Sydney North Planning Panel Meeting 06 December 2023
43-47 KENNETH STREET, LONGUEVILLE

Subject: 43-47 Kenneth Street, Longueville
Record No: DA23/72-01 - 68009/23
Division: Planning and Sustainability Division
Author(s): Greg Samardzic

| Proposed Development | Alterations and additions to an existing private hospital (Longueville Private Hospital) |
| Recommendation | Refusal |

Figure 16 – FSR Map Indicating a FSR Ratio Split on the Subject Site (on the Corner of Kenneth St and Christina St)

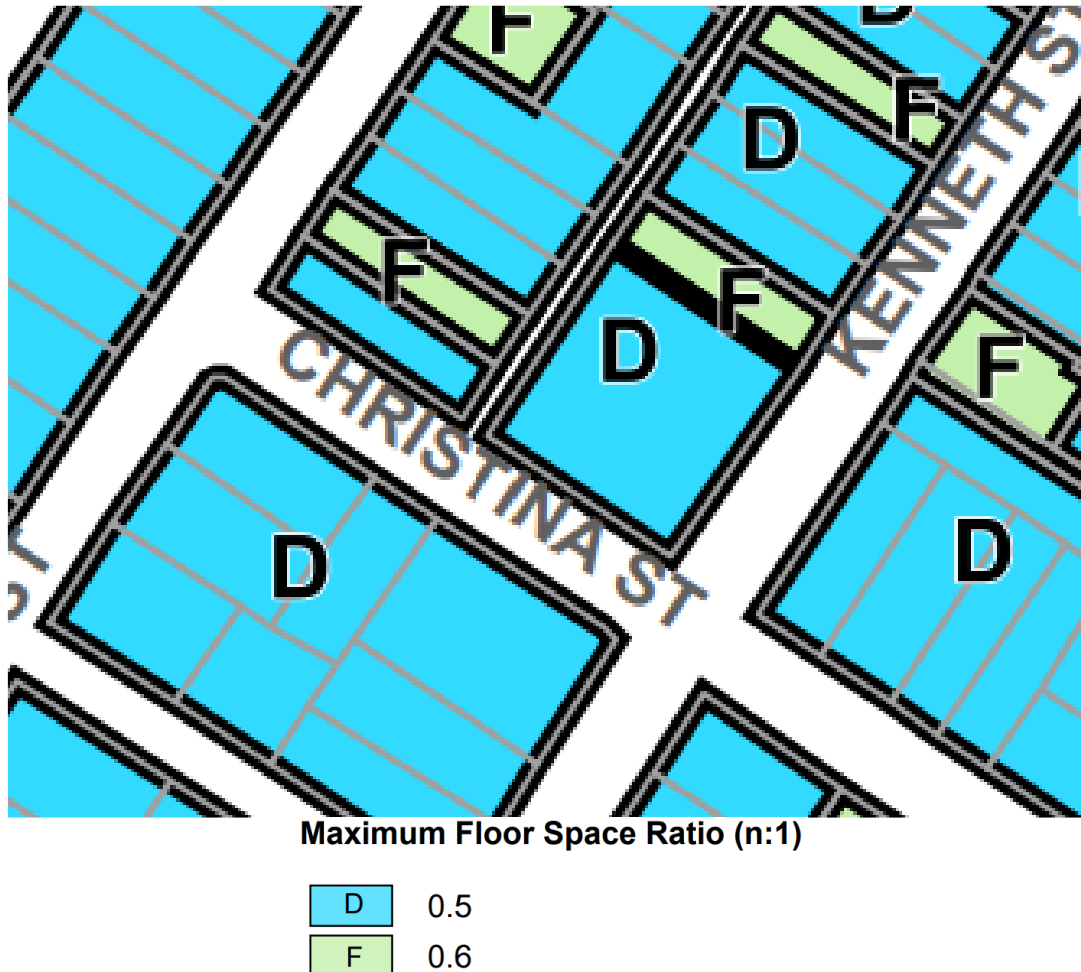
The proposed development is not compliant with the relevant numerical **0.5:1** and **0.6:1** FSR Development Standards of Lane Cove LEP 2009 affecting the subject site by a maximum of **80.5%**.

Accordingly, in relation to the component of the development located on the portion of the site on No. 47 Kenneth Street (Site Area: 2090.3m²) having a maximum prescribed FSR of 0.5:1 (1045.15m²), the development proposes 1886.6m² GFA representing an FSR of 0.9:1. This exceeds the standard by 841.45m² or 80.5%. In relation to the component of the development located on the portion of the site on No. 43 Kenneth Street (Site Area: 557.4m²) having a maximum prescribed FSR of 0.6:1 (334.44m²), the development proposes 554.8m² GFA representing an FSR of 1:1. This exceeds the standard by 220.36m² or 65.8%.

Figure 17 – DCP Rear Setback Requirement to Ensure a Rear Garden Setting is Established

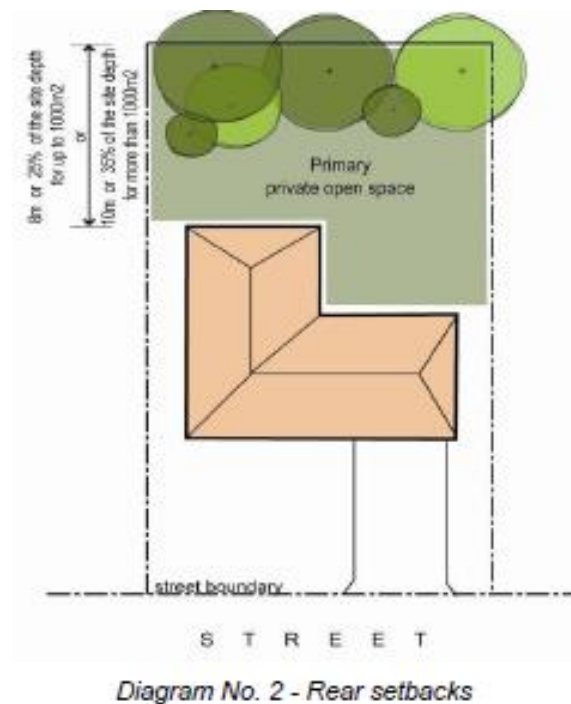
The subject site has an area of 2,647m² and has a maximum width of 47.720m. The minimum rear setback required on the subject site would be 16.7m. A nil setback for the hydrotherapy pool and a minimum 5.35m setback for the new upper level are proposed.

The proposed rear setbacks are not supported as it would not be consistent with other rear setbacks in the locality and with the existing rear setback of the adjoining dwelling at No. 41 Kenneth Street. To be discussed in further detail in this report, the proposed front and rear setbacks are not supported on the basis that it would greatly reduce the existing garden setting of the hospital facility. The reduced setbacks would also adversely impact upon existing trees which assists in providing for that much valued garden setting character and their removal are not supported in this instance. The proposal results in quite a substantial upgrade on the subject site which is commercial in nature.

Figure 20 – Proposed Increase in Scale of the Hospital Facility with Reduced Building Setbacks and Landscaped/Garden Setting

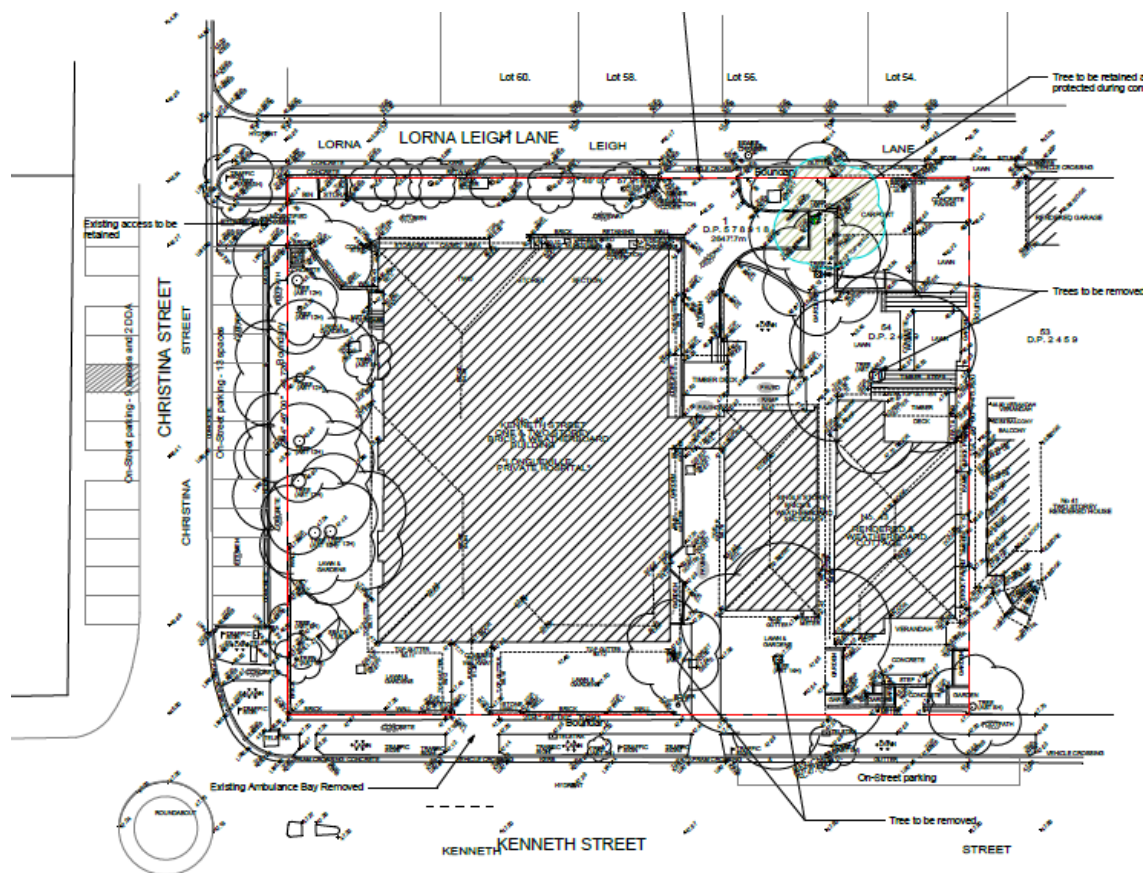
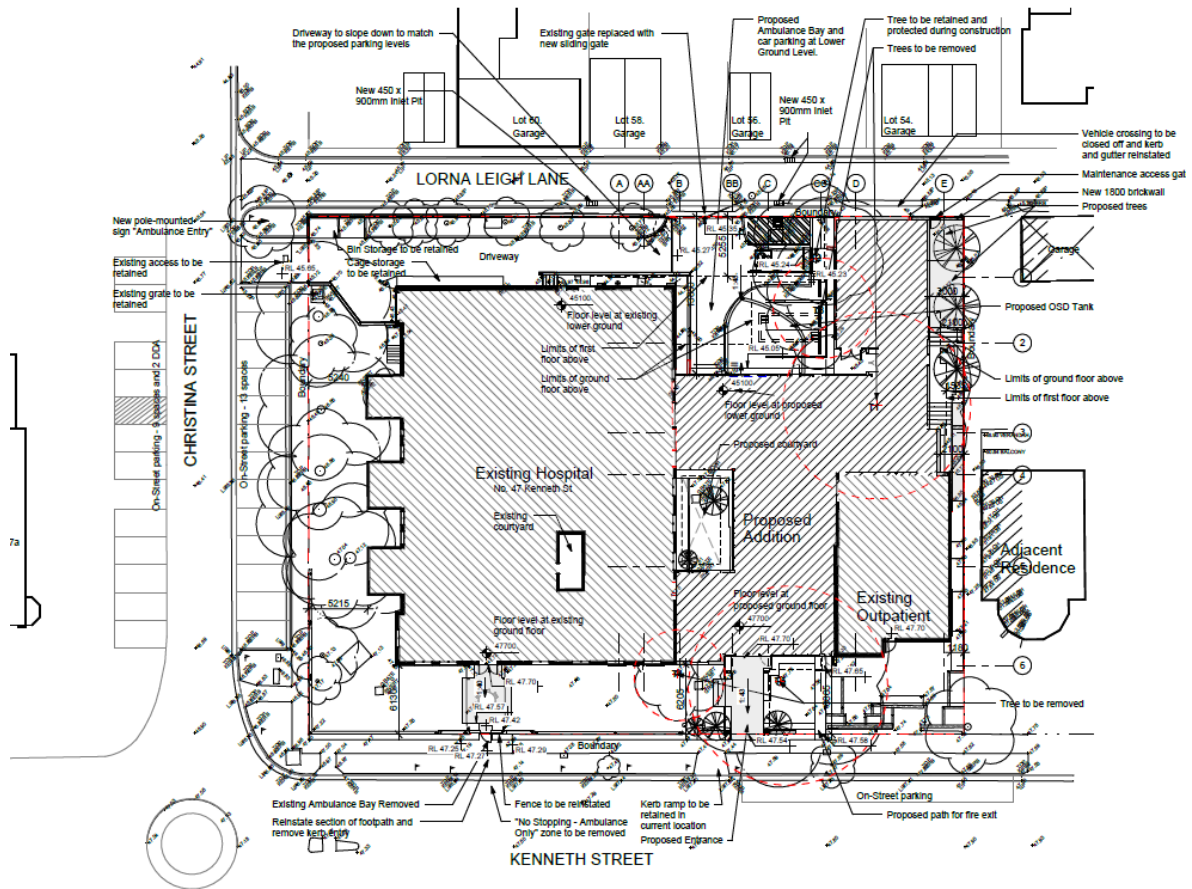
The development results in an unsatisfactory transition between residential developments within the locality as it is not appropriately located given its scale and intended use. The proposal has not been designed having regard to the existing built environment and would unacceptably impact on surrounding land uses within this zone.

Figure 22

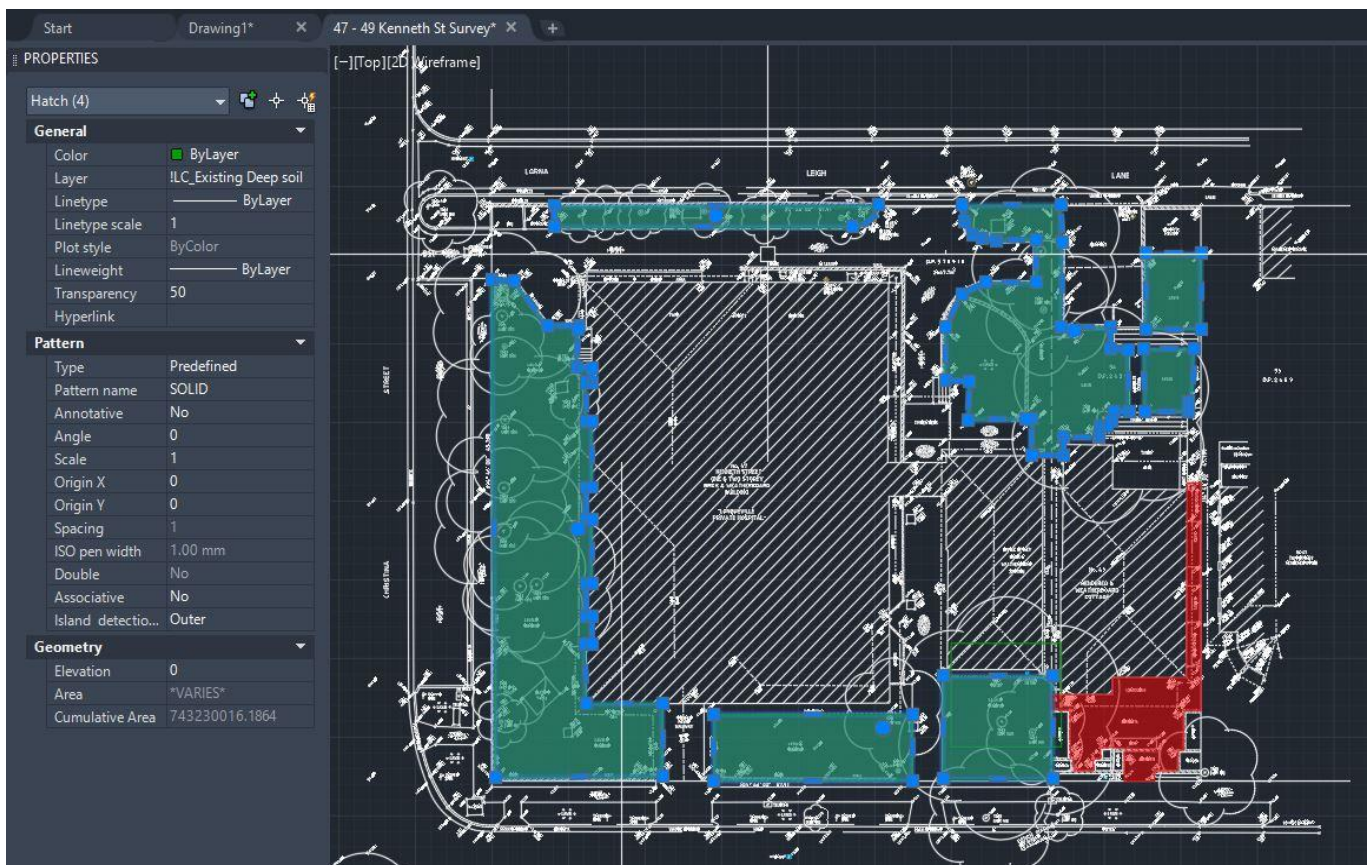
*The Landscape Concept Plan 23 036 DA 4 of 4 incorrectly calculates the area of deep soil landscaping as shown below resulting in a **shortfall of 14.84% or 393m²**.*

The green hatch areas represent the existing area to be counted as deep soil by Council = 743.23m² or 26.43%.

The red hatch area has been counted as deep soil incorrectly as this is all hardscape area = 83.13m².

Figure 25

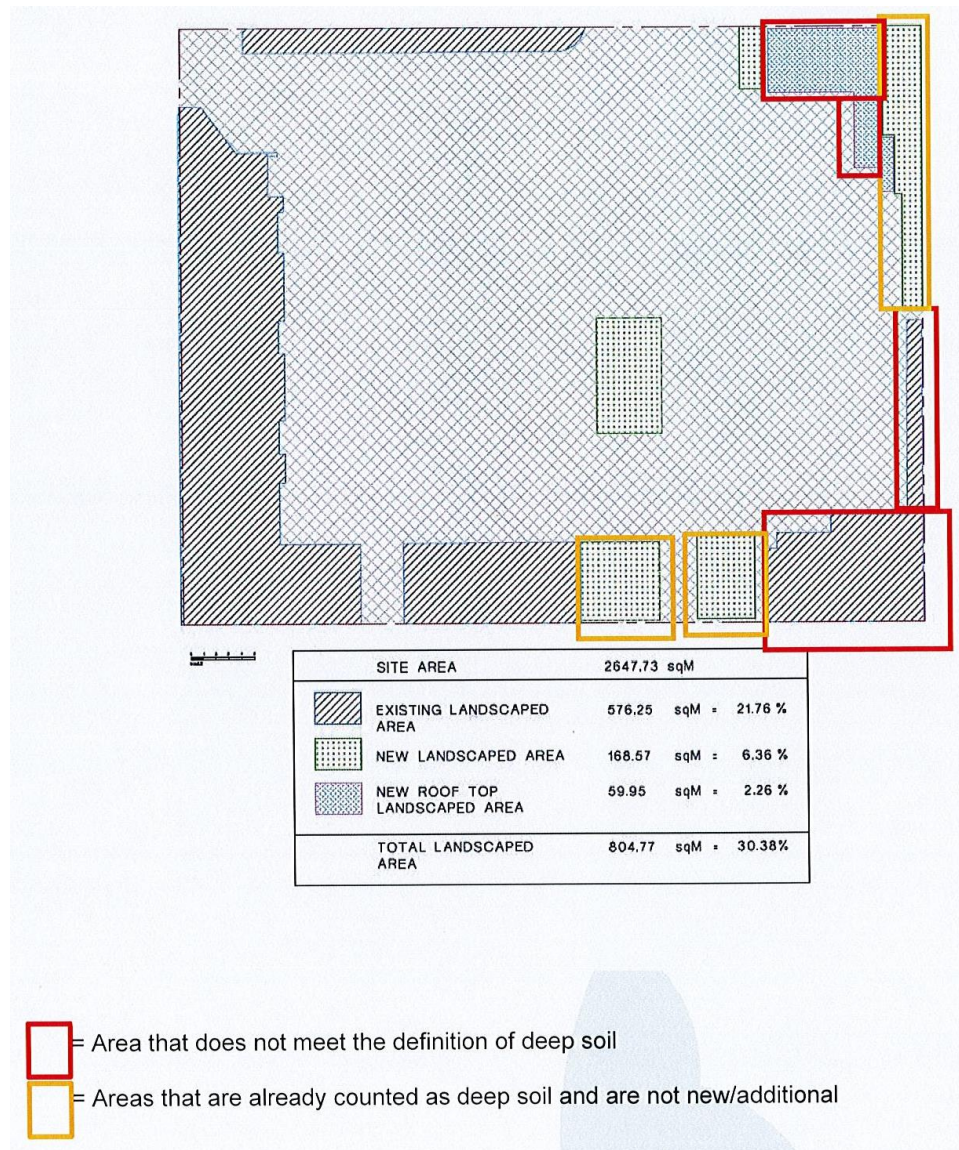
The green hatch areas represent the existing area to be counted as deep soil by Council = 743.23m² or 26.43%.
